BEFORE THE ENVIRONMENTAL QUALITY COUNCIL
STATE OF WYOMING

**RESPONDENT DEPARTMENT OF ENVIRONMENTAL QUALITY'S
MEMORANDUM IN SUPPORT OF MOTION FOR PARTIAL SUMMARY
JUDGMENT**

Permit No. CT-3030

The Division of Air Quality of the Wyoming Department of Environmental Quality has completed final review of Black Hills Corporation's application to construct a 500 megawatt (MW) pulverized coal fired electric generating facility, known as WYGEN 2, located at 13151 Hwy 51 approximately five (5) miles east of Gillette in Campbell County, Wyoming.

FIGURE 1

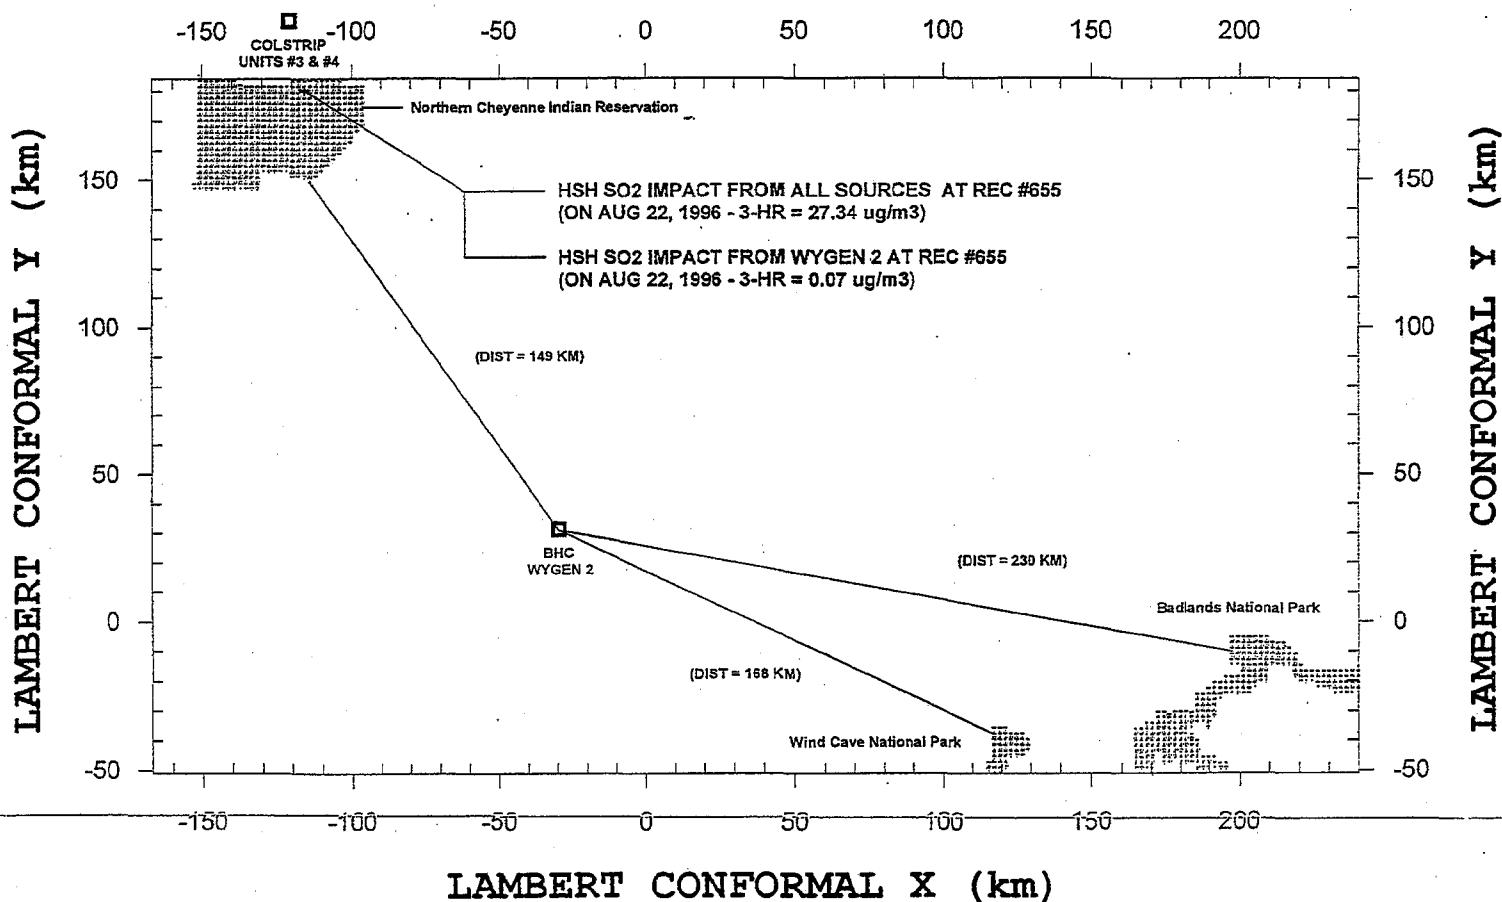
-
2. **Inclusion of Additional Sources in Class I Increment Consumption Analyses**
 - EPA and ED, et al. commented that the Colstrip Power Plant (MT), Ben French Power Plant (SD), and the South Dakota Cement Plant (SD) should also be included in the Class I increment consumption analysis.

Response - Based on comments received during the public comment period, the applicant conducted an additional cumulative Class I SO₂ increment consumption analysis and included the Colstrip power plant (Unit #3 & Unit #4). The two sources at the Colstrip facility were modeled using the allowable 3-hour and 24-hour emission rates to compare with the Class I 3-hour and 24-hour increments, respectively.

The applicant attempted to utilize a newly developed CALMET wind field created for the Division, but was unable to run all months of the annual CALMET simulation, and could not turn on the chemistry and dry deposition algorithms in the model simulations. Since the Class I SO₂ increment analysis could be run without chemistry and dry deposition turned on in the CALPUFF simulations, it was decided by the Division that a Class I SO₂ increment analysis could be completed by the applicant using this wind field. On July 2, 2002, the applicant submitted a revised cumulative Class I increment consumption analysis using a 3-hour short-term SO₂ emission rate of 0.15 lb/MMBtu.

During the Division's review of this permit application, it was determined that the surface data file (surf.dat) used by the applicant in the CALPUFF modeling simulations contained invalid surface pressure data. The Division discovered invalid hourly surface pressure data at several surface stations in the Powder River Basin were affecting the chemistry and dry deposition options. A new surface meteorological data file was generated after removing the invalid pressure data, and the Division reran the applicant's modeling simulations using the revised surface meteorological data file. Based on the Division's Class I increment consumption analysis, the highest second highest (HSH) 3-hour SO₂ impact was 27.3 µg/m³ from all SO₂ sources represented in the Class I increment analysis, indicating a single modeled exceedance of the 3-hour SO₂ Class I increment level of 25 µg/m³ at the Northern Cheyenne Indian Reservation.
